CONTENTS

18 **SUMMARY AND PURPOSE OF TESTIMONY; OVERVIEW OF RECOMMENDATIONS**

26 A. The Application concerns a proposed Power Purchase Agreement (“PPA”) the
27 Company is considering for the output of the future 345 MW nuclear power plant
28 (“Natrium” or “KU1”) to be built near Kemmerer, Wyoming. The PPA will be with US
29 SFR Owner, LLC (“US SFR”), a subsidiary of TerraPower, which designed the plant.
30 The plant is currently projected to be online at the end of 2031. The Company
31 requests a waiver under Utah Code section 54-17-501. This waiver is required
32 because a PPA from a facility of this size qualifies as a “significant energy resource”
33 (“SER”) under Utah Code section 54-17-102(9)¹ and would typically (absent a
34 waiver) require a solicitation process under Utah Code section 54-17-201 and
35 related sections. If the waiver is granted the Company seeks approval of the SER
36 acquisition under Utah Code section 54-17-302. The Company also seeks approval
37 of an asset sale (water rights for the plant) under Utah Administrative Code R746-

359 Figure 1 No-Nuclear Scenario from 2025 IRP

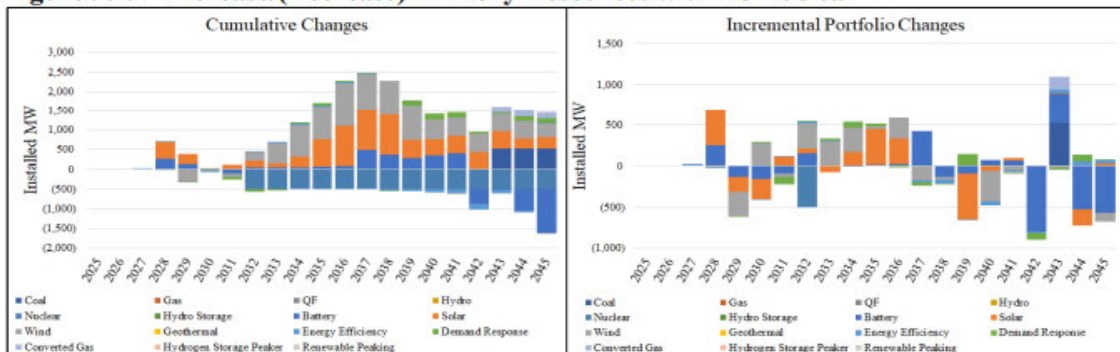
355 The Company did perform a “No Nuclear” variant in the 2025 IRP.³⁷ However, if no
356 costs were assigned to Natrium as described above, this analysis is not informative.
357 Figure 9.19 from the IRP, produced below, shows how the resource mix would
358 change without Natrium.

361 The no-nuclear portfolio shows the model selecting alternate generation resources in
362 the years leading up to 2032. It is this alternate scenario that should be compared to
363 the Natrium PPA.

410 Another way would be to re-run the no-nuclear analysis depicted in Figure 9.19 from
411 the 2025 IRP with an optimized portfolio (reproduced above in Figure 1 of this
412 testimony), and comparing this to a scenario using projected Natrium power costs.
413 This would at least compare the two scenarios (Natrium vs. the alternative mix
414 leading up to 2032). This analysis should be done with multiple price/policy
415 scenarios (e.g. high gas, low gas, etc.).

416 Therefore, at minimum, the Company should provide some basic analysis
417 comparing: (1) the preferred portfolio with Natrium using projected Natrium costs
418 (essentially Workpaper 3); and (2) some other portfolio without Natrium, where other
419 resources (as optimized by the model) are used instead (in the years leading up to
420 2031). The Division assumes the latter case would involve some mix of wind, solar,
421 battery, and/or natural gas being built (as shown in Figure 9.19 from the 2025 IRP).
422 The analysis should consider different price/policy scenarios, such as natural gas
423 price cases. It should also use a plausible capacity factor for Natrium, as discussed
424 below.
